No.: AOSBG85002

Date: 7/12/13

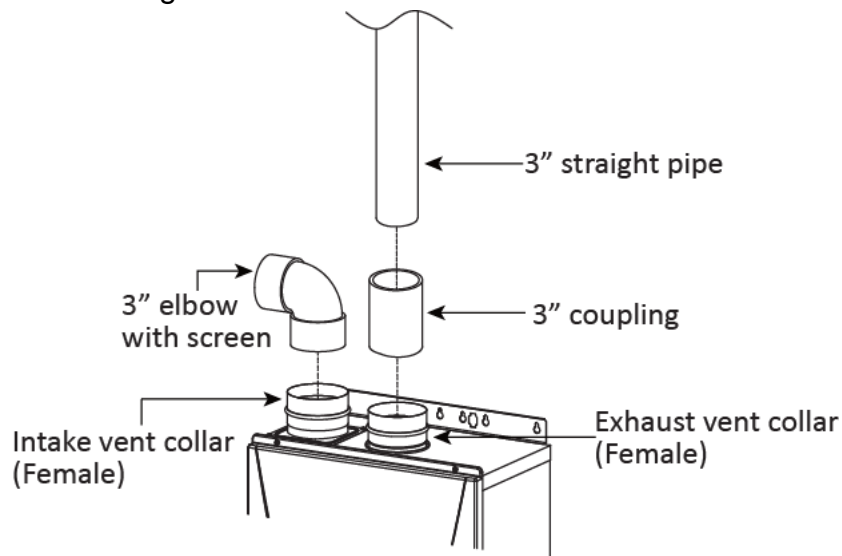
We are pleased to announce a new venting option for our indoor condensing tankless water heaters (models ATI-240H, ATI-340H and ATI-540H). Until now, combustion air for these condensing models has been drawn from outside the building. These models can now obtain clean combustion air from properly vented rooms, therefore decreasing the installation time by reducing the number of venting runs and wall penetrations. To prevent debris from falling into the heater, we recommend that the installer insert a Schedule 40 PVC 90° elbow in the intake collar, as shown in the diagram below.
